Errata 1

Manual: 31073

Manual Index: 01

Reference: Page 54, Chapter 8 – OEM Feature, Figure: Temperature Monitor

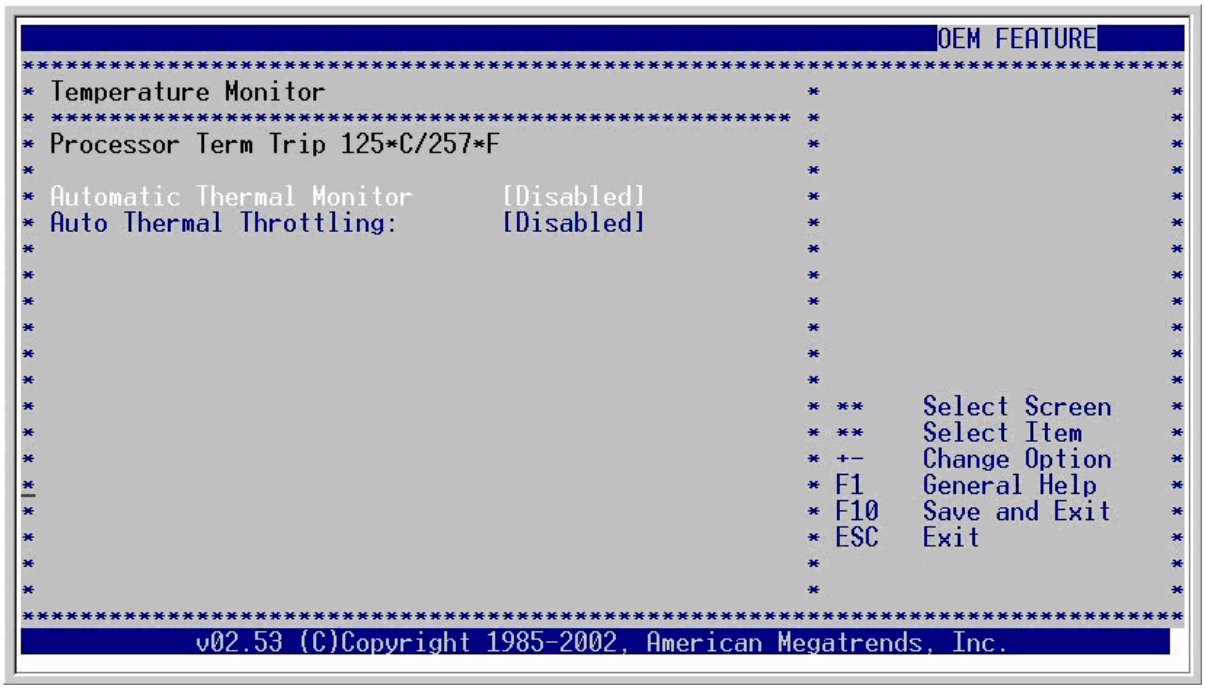
The referenced information (figure) is superseded by the following figure.
